APPLICATION NO.	FILING DATE	FIRST NAMED INVENTOR	ATTORNEY DOCKET NO.	CONFIRMATION NO.
10/510,302	10/06/2004	Fransiscus Gerardus Coenradus Verweg	NL020718US	6530
24737 7590 01/25/2008 PHILIPS INTELLECTUAL PROPERTY & STANDARDS P.O. BOX 3001 BRIARCLIFF MANOR, NY 10510			EXAMINER GETACHEW, ABIY	
			ART UNIT 2841	PAPER NUMBER
			MAIL DATE 01/25/2008	DELIVERY MODE PAPER

Office Action Summary	Application No. 10/510,302	Applicant(s) VERWEG ET AL.	
	Examiner Abiy Getachew	Art Unit 2841

DETAILED ACTION

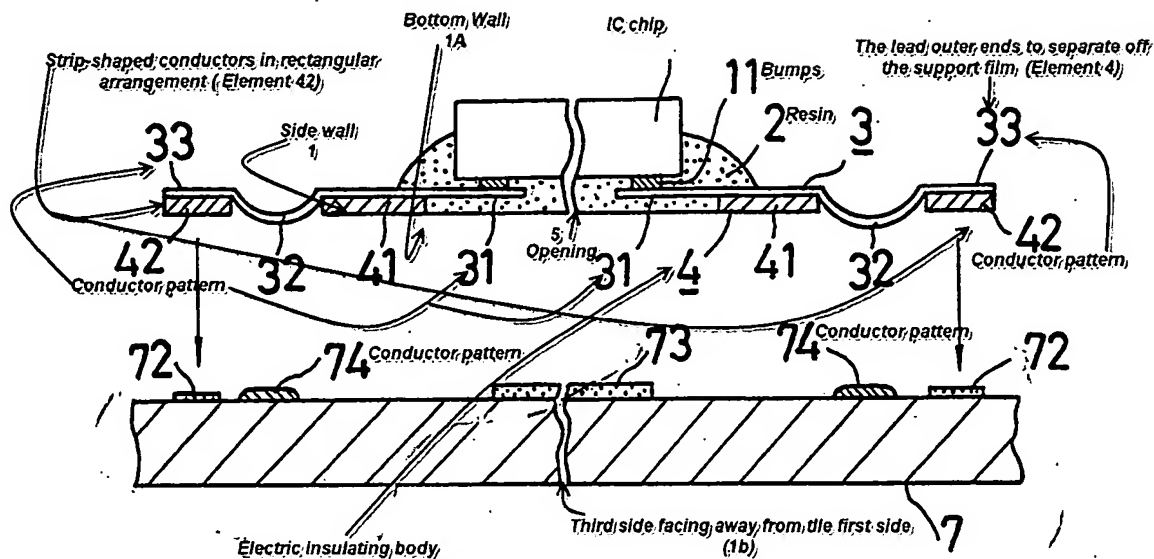
Regarding claim 1 Kitahara discloses, an electrically insulating body (Figure 16 Element 4, which comprising a polyimide substrate, glass-epoxy substrate or the like) provided with a conductor pattern (figure 16 element 31), which insulating body (Figure 16 Element 4) is provided with a first and a second side between which an enclosed angle is present of substantially less than 180 degree (See figure 16, i.e. With this surface mount component, the lead (3) which is long is folded over to a circular-arc form through an angle of at least 180 degrees), wherein the conductor pattern (Figure 16 Element 31) extends over the first and the second side (See figure 16 element 31 at 180 degree angle) and comprises a number of strip-shaped conductors provided (See Figure 28 element 32) each with at least one region of larger dimensions than the width of the strip-shaped conductors, which regions are suitable for electrical contacting of electronic elements to be assembled together with the insulating body (Figure 16 Element 31) said body acting as a carrier of the conductor pattern (42) and as a carrier of the elements (Figure 16 Element 40).

Regarding claim 2, Kitahara discloses, an electrically insulating body (4) characterized in that a cavity or opening (See figure 16 i.e. the sectional view showing how to surface-mount the component on a wiring board with cavity (Figure Element 5) is present in the body)

Regarding claim 3, Kitahara discloses, characterized in that the cavity (Figure in claim 1 Element 5) has a bottom (See Figure in claim 1, Element 1A) and a side (See Figure in claim 1, Element 1A) wall, the conductor pattern (Figure 16 element 31) extending over the side wall and optionally over the bottom of the cavity (See Figure in claim 1 Element 5), while a connection region for electrical contacting of the electronic element (Figure in claim show the IC) which connected to a plurality of leads) is present in the cavity (Figure Element 5).

Regarding claim 4, Kitahara discloses characterized in that the opening (Figure 16 Element 5) extends from the first side (Figure in claim 1 Element 1) through to a third side (Figure in claim 1 Element 1B) facing away from the first side (Figure in claim 1

Element 1), such that a first component (Figure in claim 1, the IC chip) can be placed at the first side (Figure in claim 1 Element 1) and a second component can be placed at the third side (Figure in claim 1 Element 1B), which components together with the interposed body define an electronic element (Figure in claim 1, the IC chip) . (See figure in claim 1 for sectional view showing how to surface-mount the component on a wiring board)

Regarding claim 5, Kitahara discloses, characterized in that at least a number of the strip-shaped conductors (Figure in claim 1 Element 33) is provided with respective regions at respective ends (See the figure in claim 1) which regions act as connection regions and are located in a closed, preferably rectangular arrangement. (See figure 16)

Regarding claim 6, Kitahara discloses, characterized in that at the body has a third side (Figure in claim 1 Element 1B) which faces away from the first side (Figure in claim 1 Element 1), and the conductor patten (Figure in claim 1 Element 33) extends from the first side (Figure in claim 1 Element 1) over the second side (Figure in claim 1 Element 1A) onto the third side (Figure in claim 1 Element 1B).

Regarding claim 7, Kitahara discloses, characterized in that at least a number of the strip-shaped conductors (Figure in claim 1 Element 33) have respective strip-shaped ends (Figure in claim 1 Element 42), said ends being at least substantially oriented in parallel and present at the first side (Figure in claim 1 Element 1).

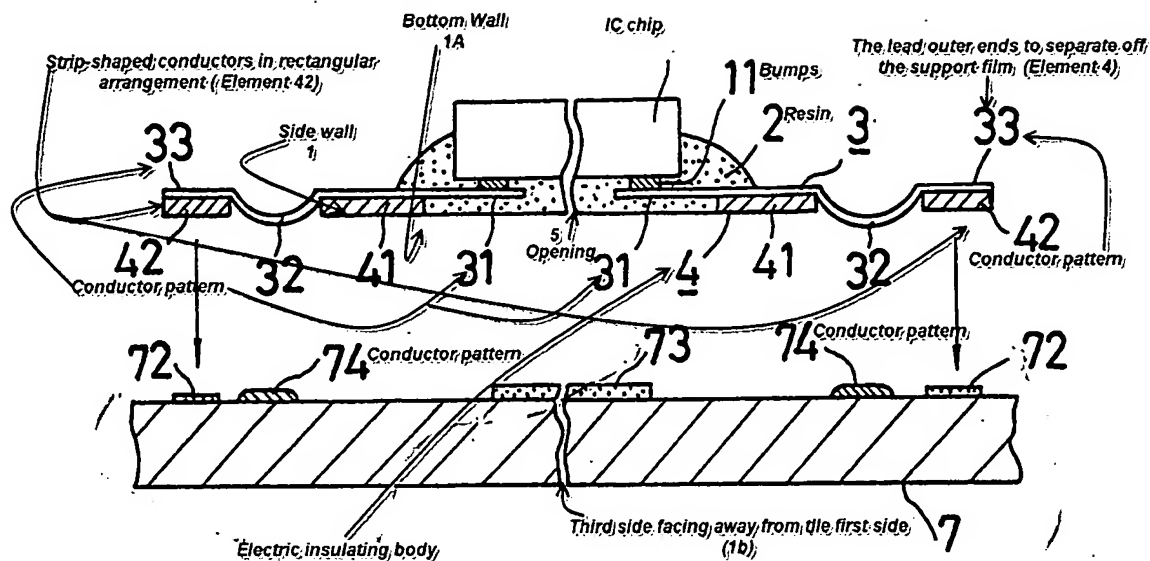
First, Applicant argues that "Nowhere does Kitahara teach or suggest a recessed conductor pattern in a first and second side of an insulating body as recited in claim 1"

In response to the above argument, Applicant's attention respectfully directed to the figure below. Examiners interpretation of recessed conductor pattern is as it depicted in figure below, a mounting method requiring a cutout be made into the finished wall or other surface. Recessed equipment will be recessed into the wall so the mounted object protrudes little from the face of the wall.
